Objection Letter - Ms Burns

Response

- 1.1. This is the scope of evidence regarding the objection to Stonehaven Flood Protection Scheme from Ms Burns
- 1.2. This evidence starts by describing the public consultation undertaken and how images have been used in the development of the scheme and the relationship with the Flood Risk Management Act application.

Figure 1

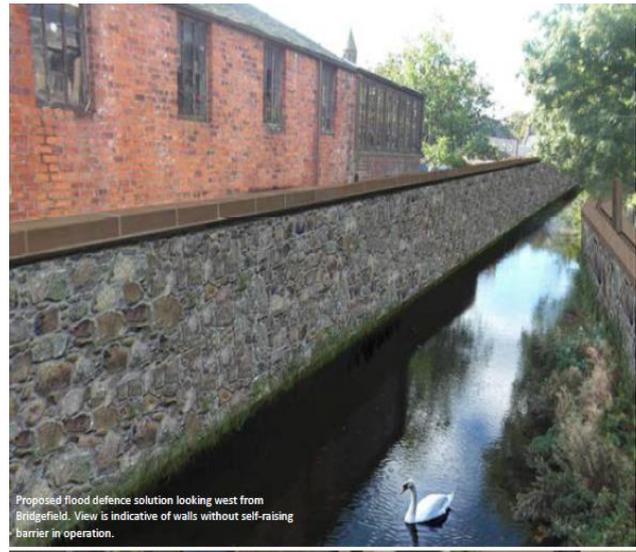
In the first instance the scheme has been altered since the public viewing of the plans earlier in the year – the walls are now two feet higher than was presented to the public. This has implications for residents and for eventual cost and as modifications have been made the public need to me made aware accordingly. Many residents will have seen the exhibition at the Bowling club and will take those plans as the ones that have to be considered. This is misleading when the plans have already been modified.

- 2.2. In May 2015 a public exhibition was held to give an indication of the scheme at that moment in time. On display were a variety of technical drawings and a small number of artist impressions of material finishes, stone types, bridge options and landscaping ideas. (fig1 & fig 2)

- 2.3. One image/artist impression on display was of the proposed wall outside 19 Bridgefield (fig 2). No actual levels were shown as it was intended to provide an impression of the wall finishes. The final proposal for this section of wall does have window and a door opening and is slightly higher. It is recognised that this image could have been interpreted as the finished height.

- 2.4. In the same approach, a number of the artist impressions, such as the bridge shown in (fig1) was taken from a variety of sources and do not directly represent Stonehaven.
